Exelon Generation Company, LLC

Braidwood Station, Unit 2
Facility Operating License No. NPF-77
NRC Docket No. STN 50-457

Subject: Response to Request for Additional Information Regarding the Steam Generator
Tube Inspection Report for Braidwood Station, Unit 2, Refueling Outage 17

Three-Tube Periphery Array Probe (X-probe) Inspections Tube sheet Maps

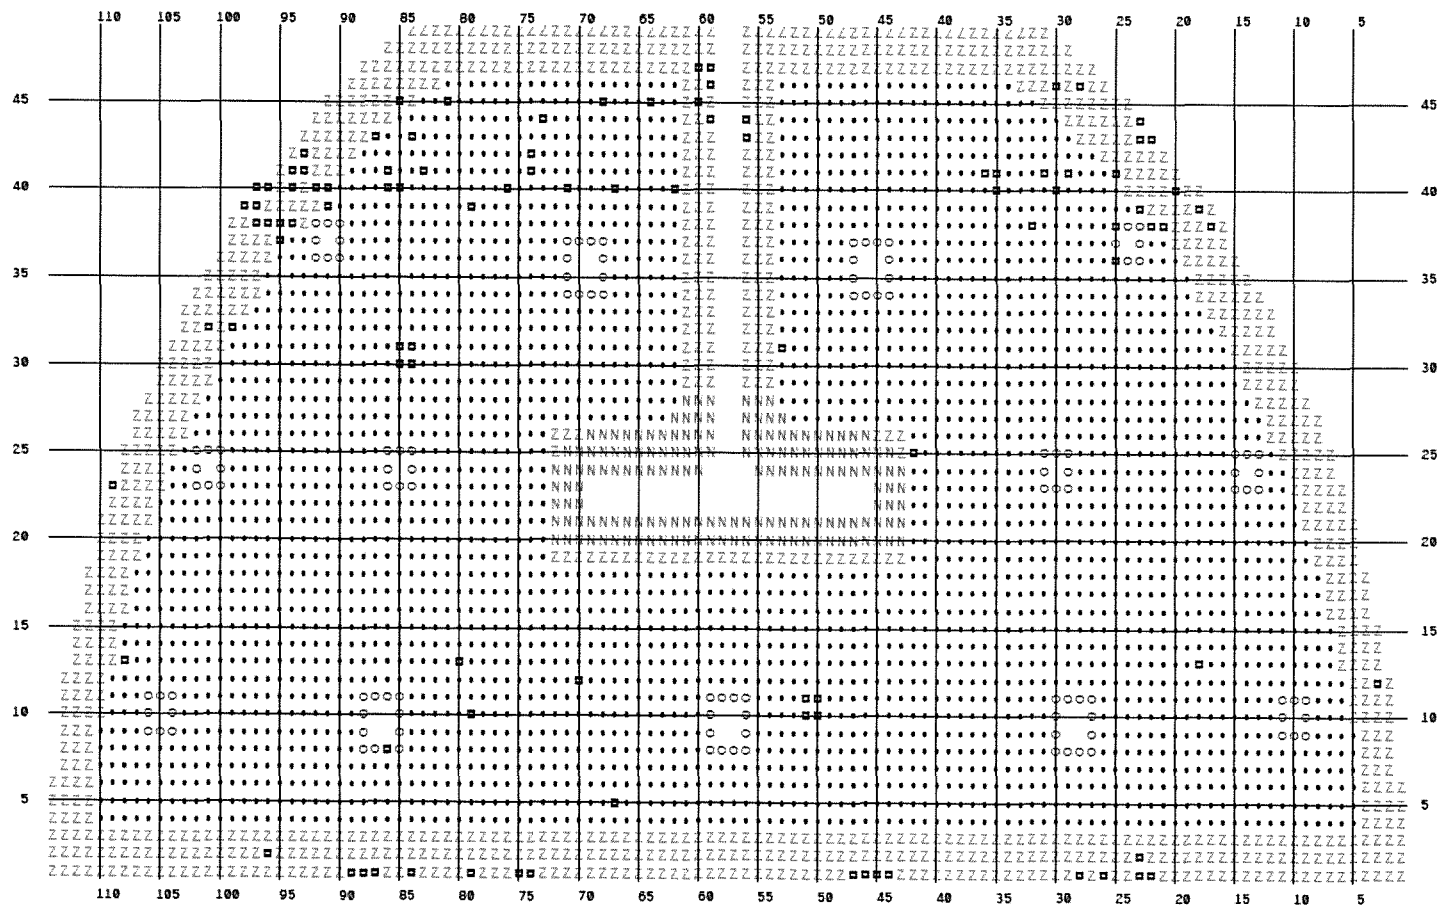
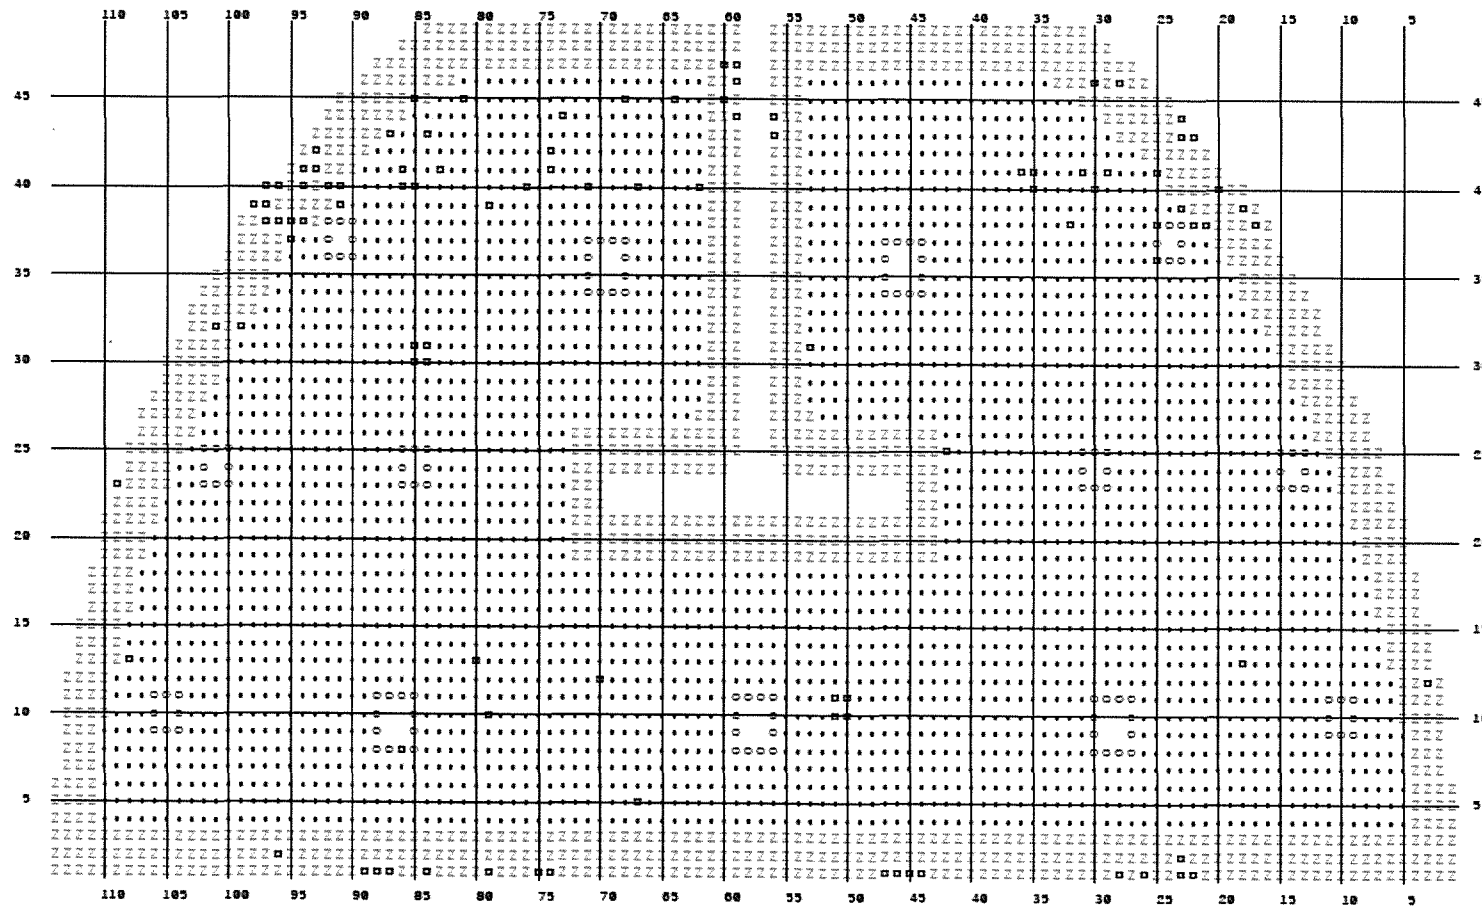
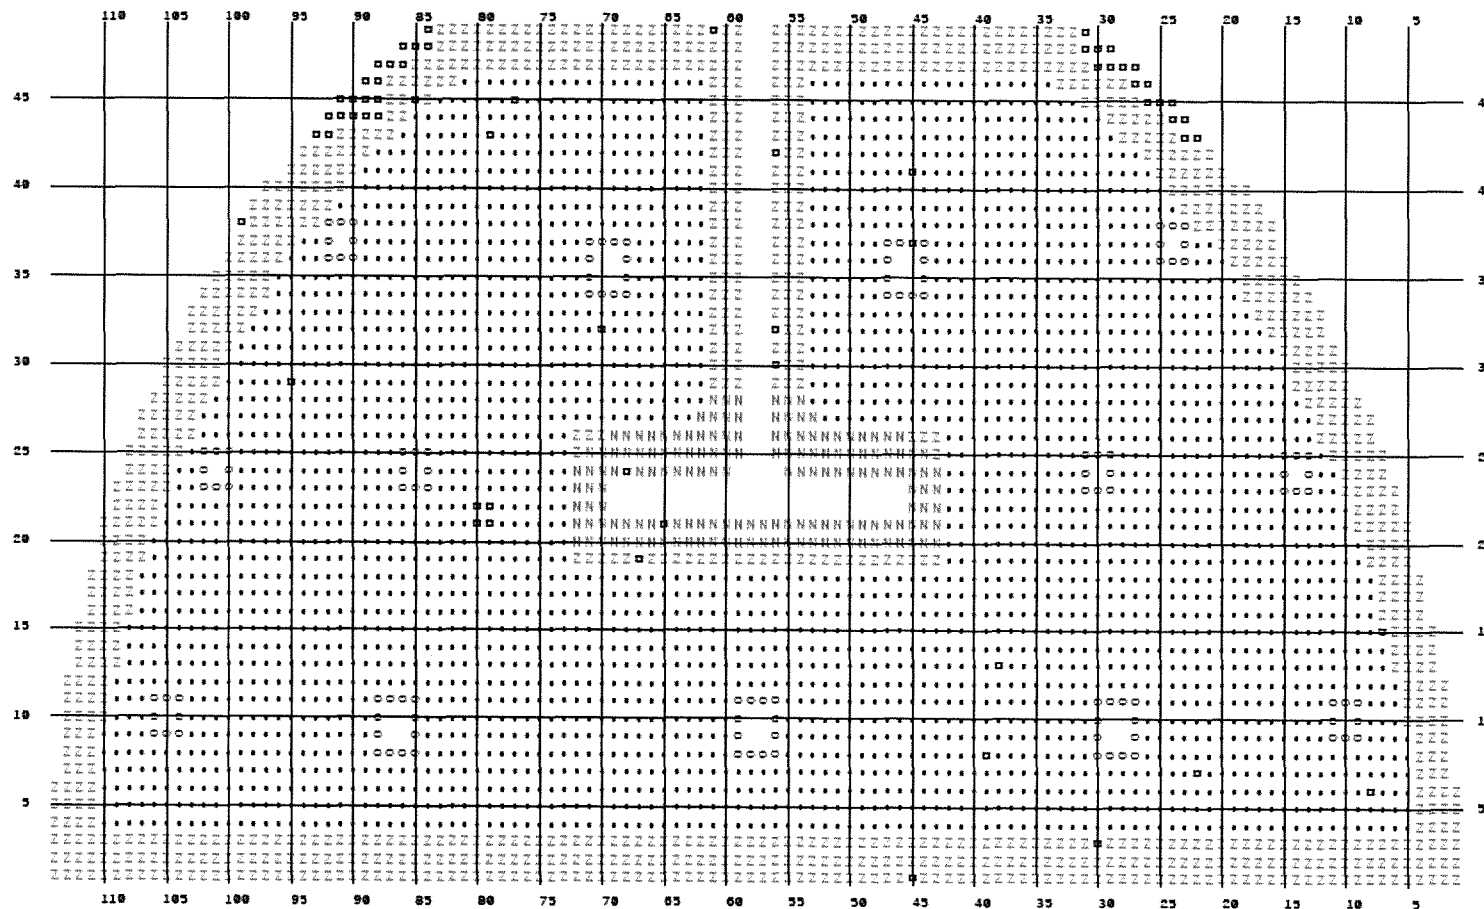
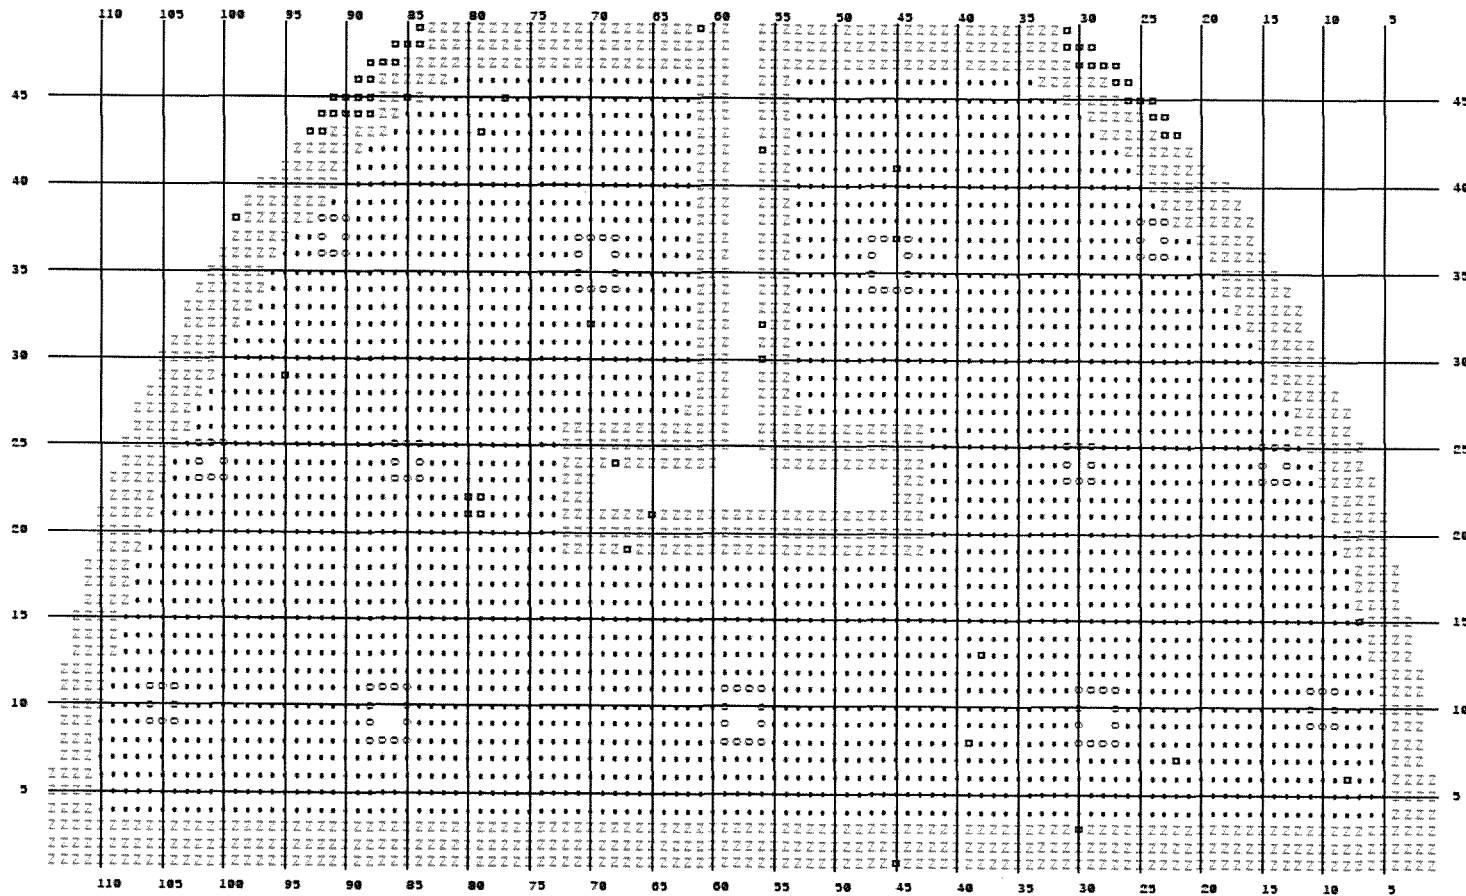
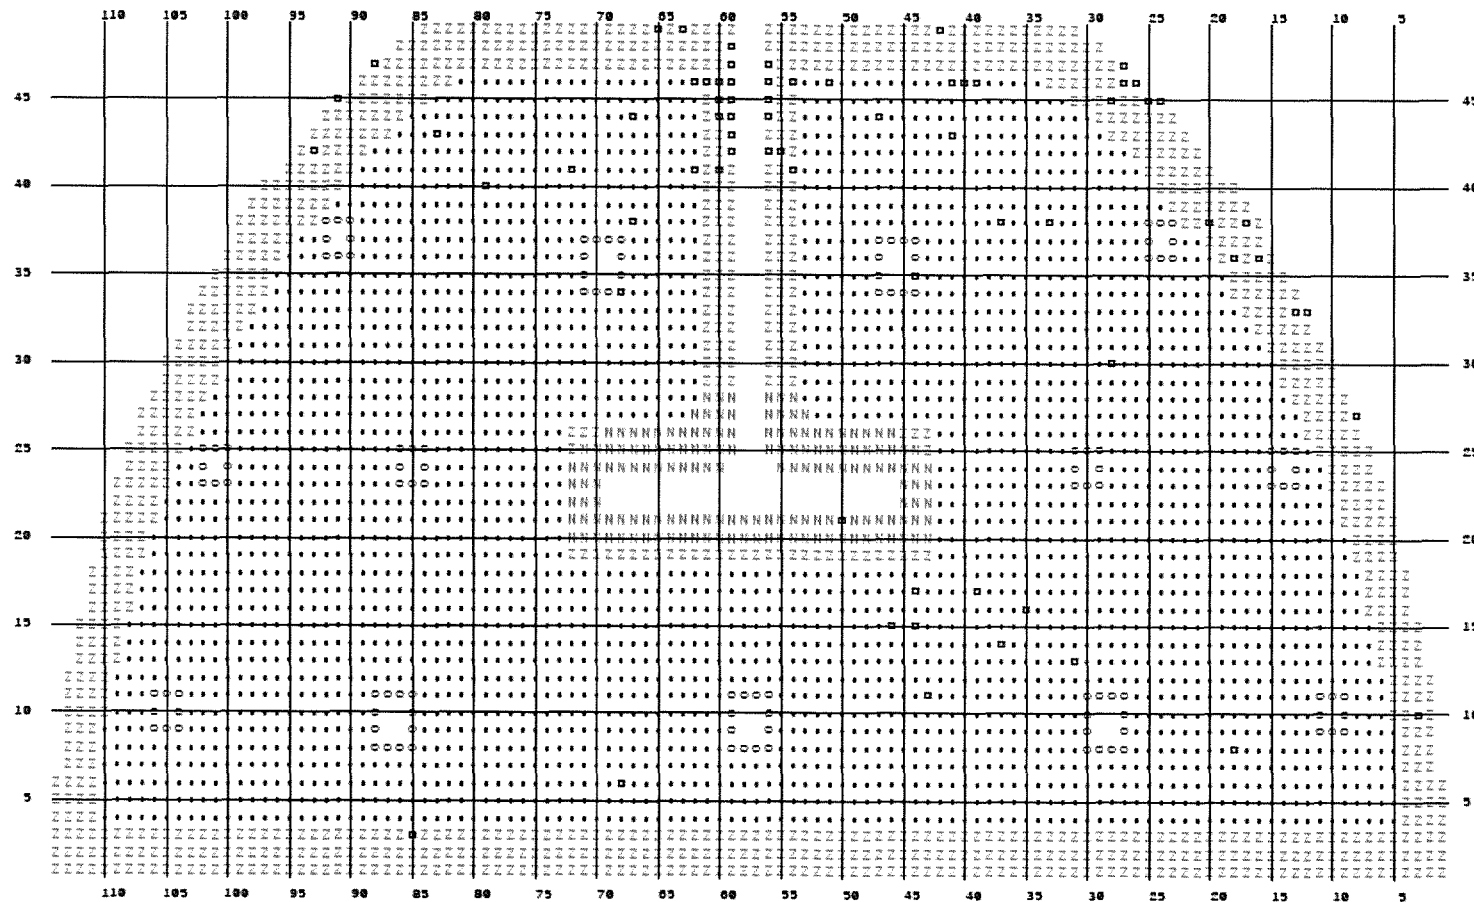
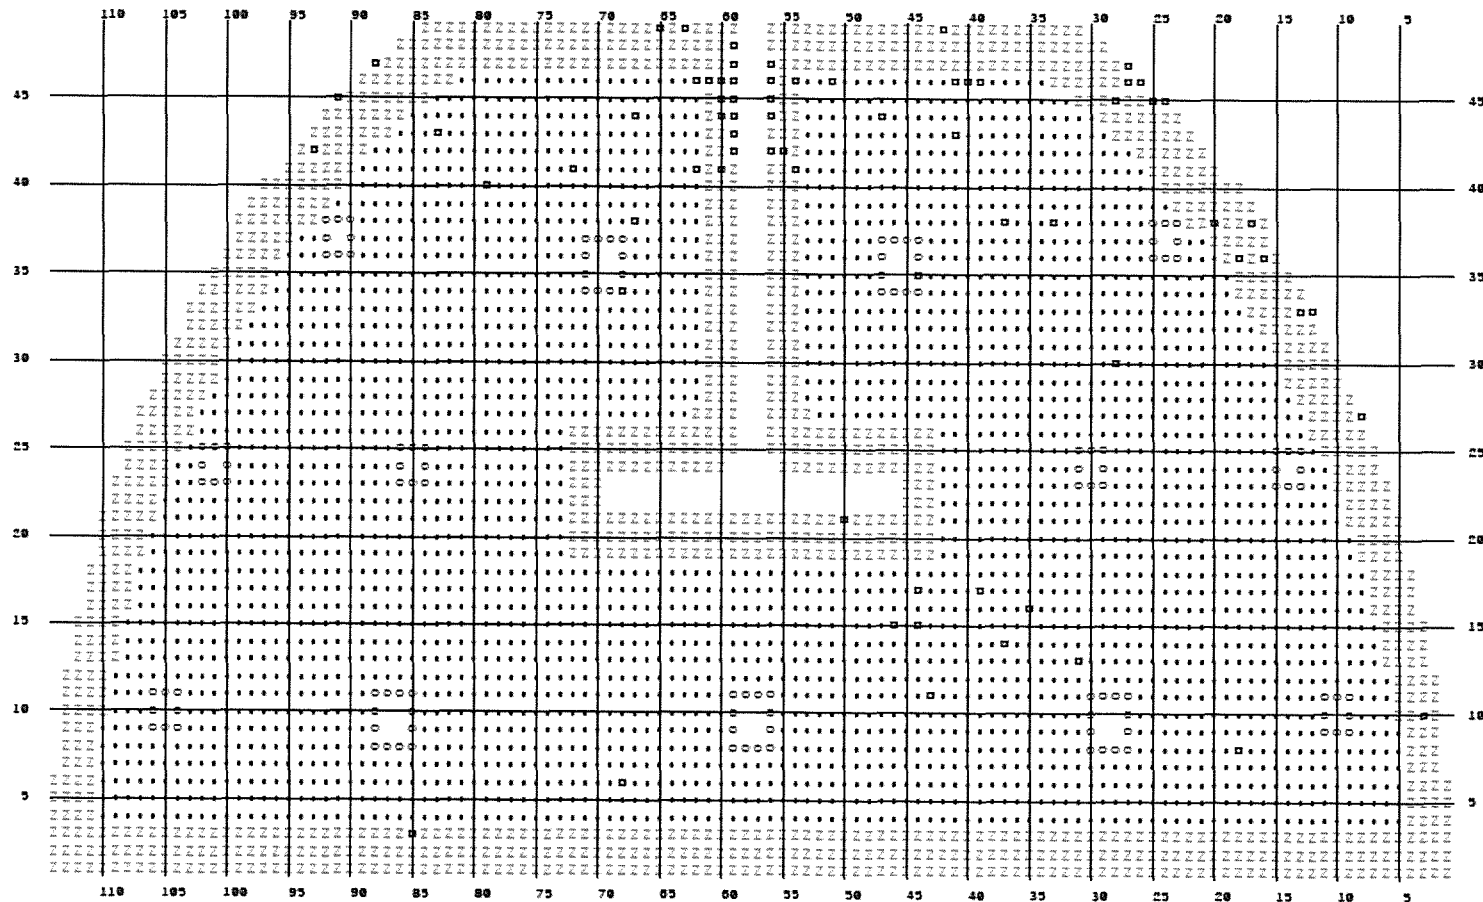
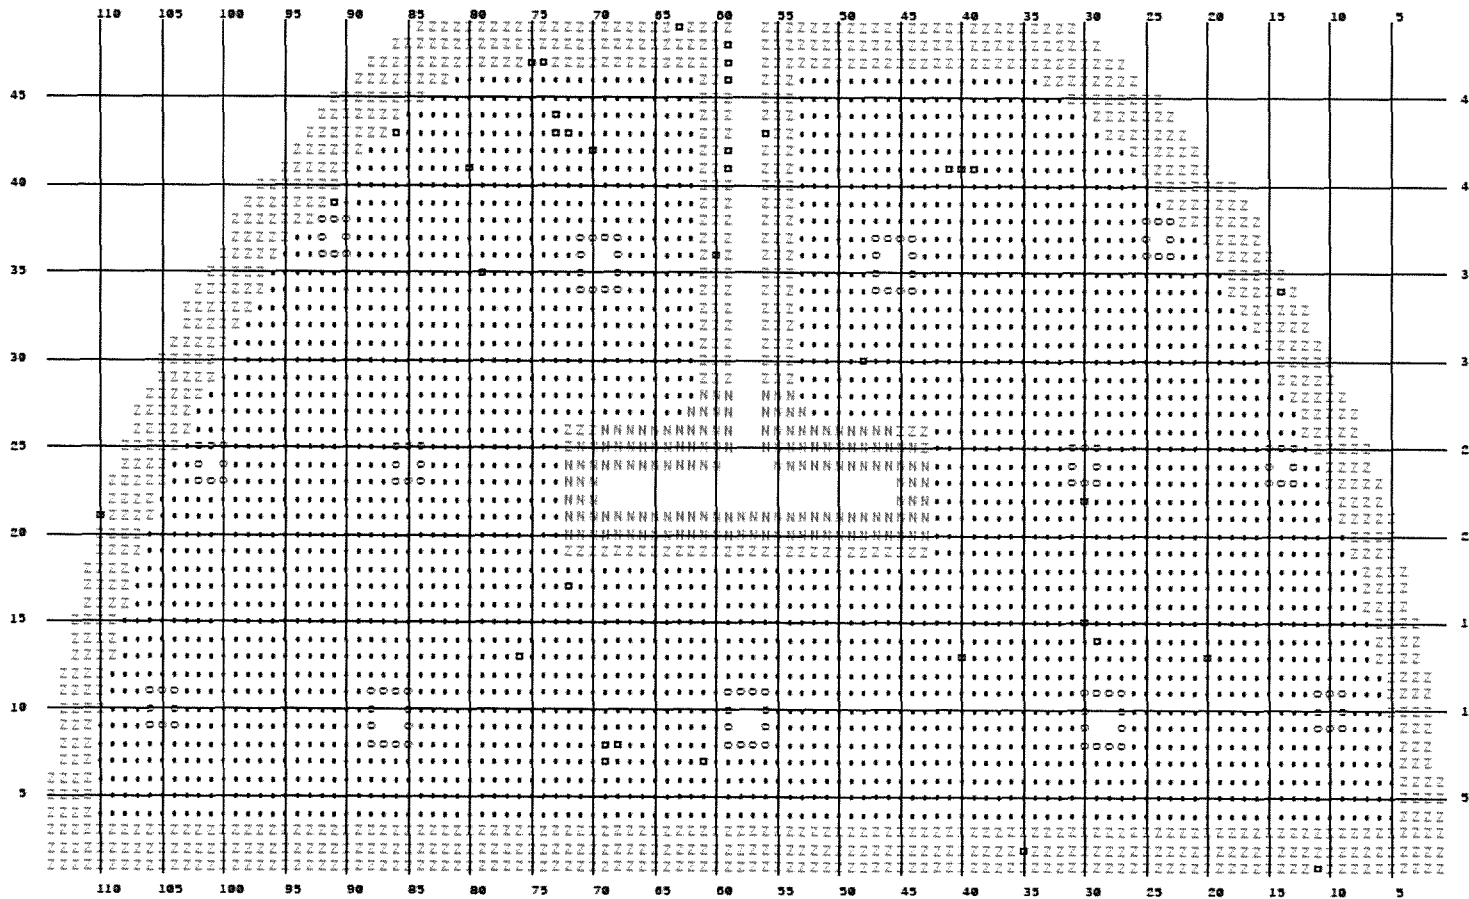
Your November 14, 2014, submittal indicated that three tubes deep around the entire periphery, including the no tube lane and T-slot, were inspected in all four SGs with an X-probe. Clarify the axial extent of these exams (e.g., tube-end to tube-end, H distance to first support on both hot-leg and cold-leg). Discuss whether or not these exams included both hot-leg and cold-leg regions.*

The axial extent was the tube end to flow distribution baffle (1st Tube Support Plate (TSP) -01C or 01H) for the entire periphery scope, including the no tube lane and T-slot. In the "head" of the T-slot on the hot leg, the extent of the exam was extended from 01H to 03H. The exams included both the hot leg and cold leg regions. This is shown in the attached tube sheet maps in Attachment B.
